Subject: AP1000 COL Revised Responses to Request for Additional Information (TR #54)

Responses to Requests for Additional Information on Technical Report No. 54

AP1000 TECHNICAL REPORT REVIEW

Figure 9.1-2 (Sheet 1 of 2) Region 1 Spent Fuel Storage Rack Layout

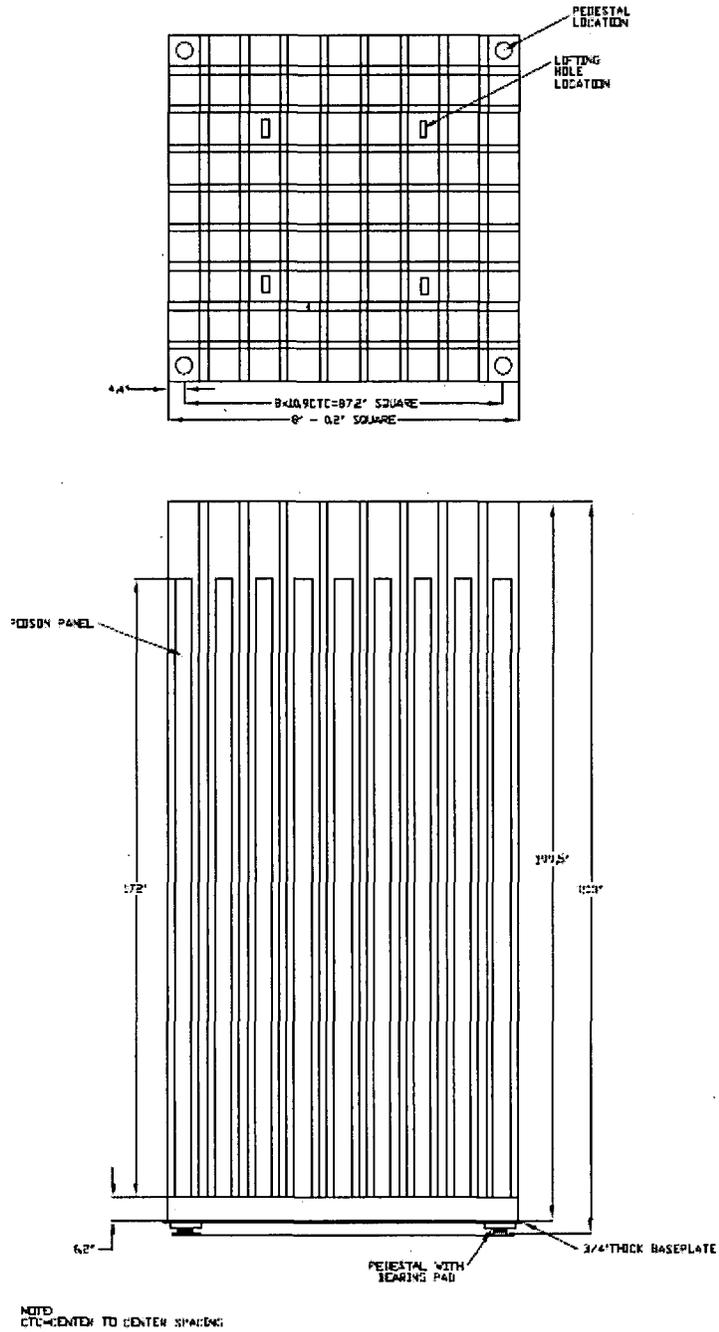
- (3) Figure TR54-15.6 (in the RAI response) does not show any leak chase channels in the spent fuel pool floor. W indicated that there are leak chase channels; however they are not shown in rack layout figure. W confirmed that the fuel rack analyses did not consider the possible impact loading of a rack pedestal over the leak chase channel. Therefore, the staff request W to explain why the effects of the leak chase channel were not considered in the fuel rack analyses and the calculation that demonstrates the adequacy of the liner/concrete in the local region around the pedestal which is part of the TR report. Also, Figure TR54-15.6 which will be included in the TR should be revised to show the leak chase channels if they are used.

Westinghouse has revised the layout figures for Region 1 and Region 2 spent fuel racks as requested. These figures are presented below in the DCD Revision and TR Revision sections below. Leak chases are used in the spent fuel pool. The plates making up the spent fuel pool liner have been designed such that no rack pedestals are over leak chases.

The spent fuel rack figures in section 9.1 of DCD revision 16 are replaced with the following figures:

Figure 9.1-2 (Sheet 2 of 2) Region 1 Spent Fuel Storage Rack Cross Section

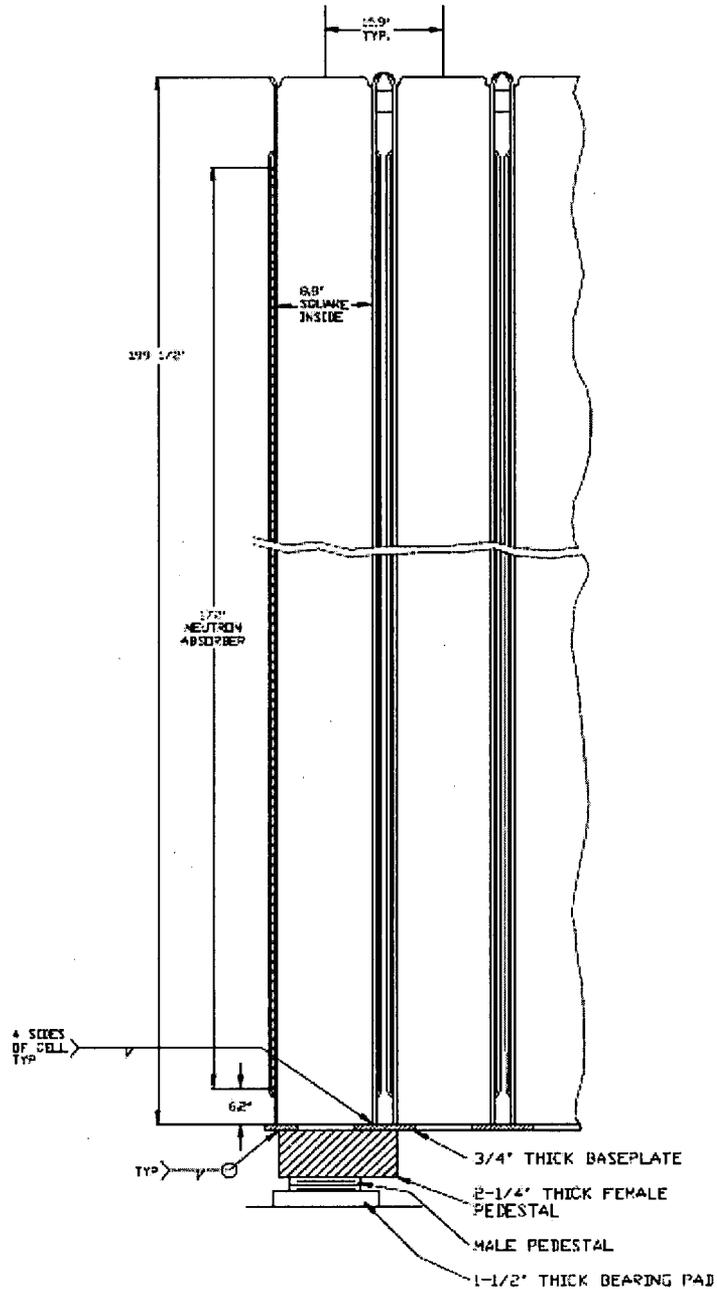
- (1) The key dimensions of the male and female pedestal components and bearing plates should be shown in the figures provided in the RAI response.
- (2) The welds connecting the pedestals to the baseplate and the baseplate to the fuel cell walls are not shown. The information for the welds should indicate the type of the weld (e.g., fillet) and whether they are all around or the extent of the welds.

Figure TR54-16.1

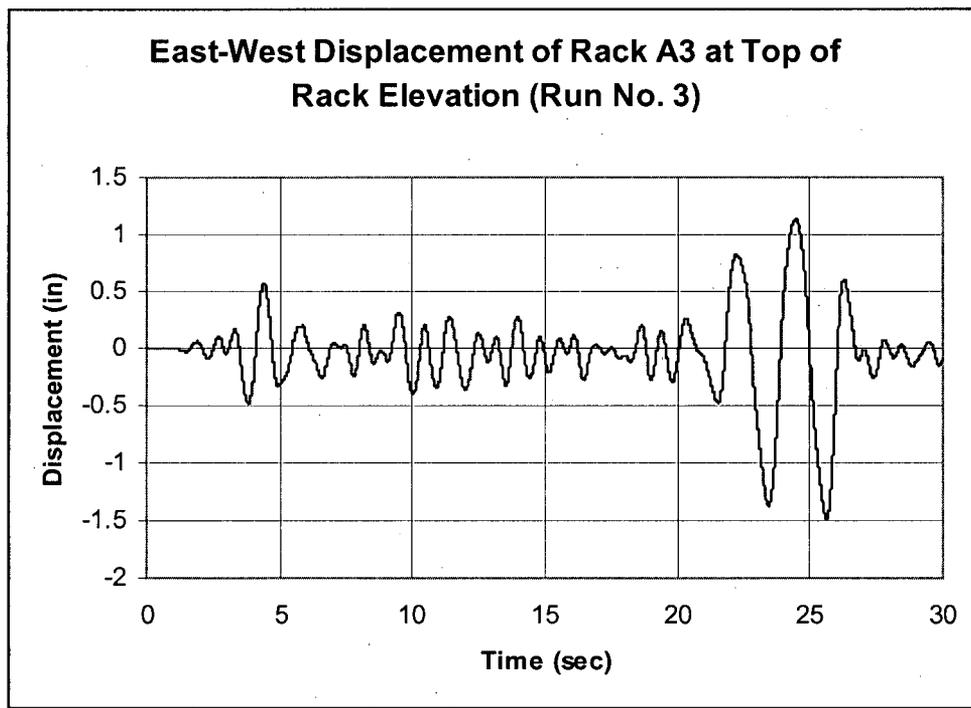
5. ...The staff review of the response spectra shows that at 7Hz the response spectra peak is still flat until about 10 Hz and does not drop off significantly until above 30Hz. Therefore, W is requested to explain why the use of 7 Hz as the highest frequency of interest is appropriate since at higher frequencies, the damping would be lower resulting in higher response.

5. The use of 7Hz is justified based on the predicted response of the spent fuel racks under seismic conditions. The figure below shows the displacement of spent fuel rack A3 in the east-west direction, at the top of rack elevation, versus time for the 30-second SSE event. The peak displacement of 1.486" is the maximum "top of rack" displacement for all spent fuel racks from all of the dynamic simulations performed in Holtec Report No. HI-2063523, Spent Fuel Rack Structural/Seismic Analysis for Westinghouse AP1000, Rev. 1 (APP-FS02-S3C-001). Based on visual inspection of the displacement plot, the predominant response frequency of the spent fuel rack due to the design basis SSE loading is below 2Hz. Therefore, it is conservative to use a frequency of 7Hz to calculate the amount of structural damping in the dynamic model, since it results in less input damping (as compared to a frequency of 2Hz) and, in turn, increases the response amplitude (i.e., higher displacements, pedestal loads, etc.).

Figure TR54-27.1 Planar View of an 8 Rack Array

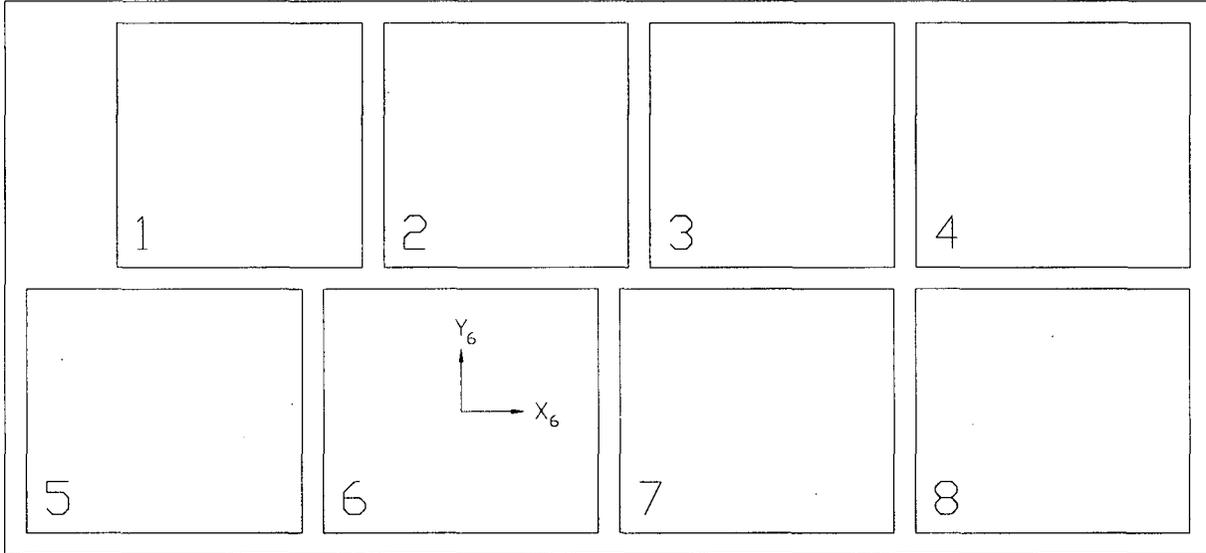
Provide more detailed information about how the fluid coupling was calculated and implemented in the AP1000 simulations. Describe the approaches used for fluid coupling of fuel assemblies to fuel cell walls, rack to rack, and rack to pool wall because there would be some differences among these. For the rack to rack and rack to wall fluid coupling, explain how fluid flow was considered horizontally as well as vertically over the top of the racks and flow to the bottom of the rack. Describe and justify any assumptions made in the approach. For example, small vibratory deflections relative to the gaps are probably assumed and the fluid gaps are not updated according to the rack displacements (see Section 2.4 of the report).

The problem to be investigated is shown in Figure TR54-27.1, which shows an orthogonal array of 8 rectangles which represent a unit depth of the 8 spent fuel racks in the AP1000 Spent Fuel Pool. The rectangles are surrounded by narrow fluid filled channels whose width is much smaller than the characteristic length or width of any of the racks. The spent fuel pool walls are shown enclosing the entire array of racks.
